# Champlain Hudson Power Express Transmission Line Project Environmental Impact Statement

## Volume III: Appendix P Comment Response Document

**COMMENT RESPONSE DOCUMENT FOR THE  
CHAMPLAIN HUDSON POWER EXPRESS TRANSMISSION LINE PROJECT  
DRAFT ENVIRONMENTAL IMPACT STATEMENT**

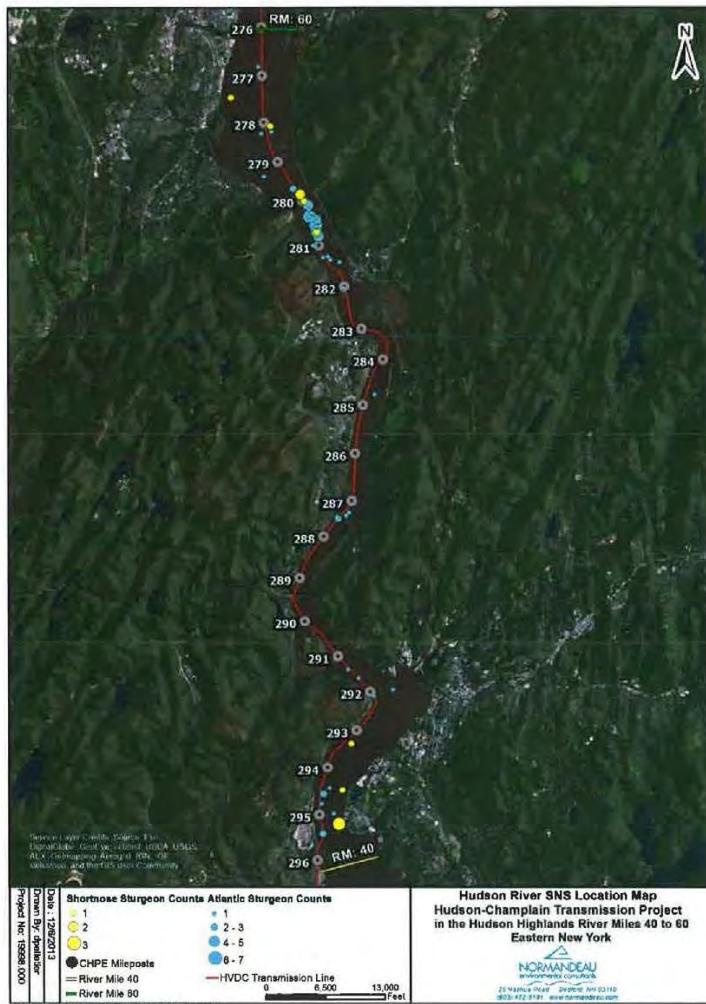
The 2012-2013 HRBMP collected a total of 121 Atlantic Sturgeon and 57 Shortnose Sturgeon during the one-year period from 29 August 2012 through 28 August 2013, and these sturgeon were caught primarily in 3-m beam trawl samples deployed to collect fish living directly (i.e., within 0.7 meters or 2 feet) in association with the river bottom substrate at randomly selected locations throughout the Hudson River Estuary. When the GPS locations of trawl samples catching sturgeon are overlaid on the maps of the CHPE Hudson River Segment transmission line route (Figure 1), it is apparent that more than half (65 fish or 54%) of the total catch of 121 Atlantic Sturgeon came from the upper portion of the Hudson Highlands SCFWH located between Denning's Point and Constitution Island (HRMs 53-59; CHPE MPs 277-283). More importantly, nearly all of these juvenile Atlantic Sturgeon (52 fish out of 65 fish or 80%) came from just one mile of the Hudson Highlands SCFWH (HRM 55; CHPE MPs 280-281) adjacent to Storm King Mountain that is directly in contact with the substrate along the proposed route of the CHPE transmission line (Figure 1). Nearly all of the juvenile Atlantic Sturgeon caught during 2012-2013 from the Hudson Highlands SCFWH near Storm King Mountain were caught during the late summer and fall, indicating that this area is an important and previously undiscovered overwintering habitat for juvenile Atlantic Sturgeon. Thus, any cable embedment activities should avoid this location and sensitive time period to protect the sturgeon. Shortnose Sturgeon also inhabit the same upstream portion of the Hudson Highlands SCFWH as evident by their catch in the 2012-2013 HRBMP (Figure 1). Based on these new observations, in conjunction with the uncertainties about operational EMF and construction impacts on these two federally-listed endangered sturgeon species (Section 2.2 above), and the exact spatial juxtaposition of both overwintering juvenile Atlantic Sturgeon and the CHPE Project transmission corridor, we conclude that at least the upper portion of the Hudson Highlands SCFWH should be avoided by an overland route to protect the sturgeon.

**820-57:** As noted in the comment, the potential for impact to this SCFWH would be minor, and the transmission line installation has been approved by the New York State agencies with jurisdiction over SCFWHs. The NYSDOS and the NYSDEC have approved the proposed CHPE Project installation in the SCFWHs through the issuance of the NYSPSC Certificate, the Coastal Consistency Determination, and the issuance of a Section 401 Water Quality Certification.
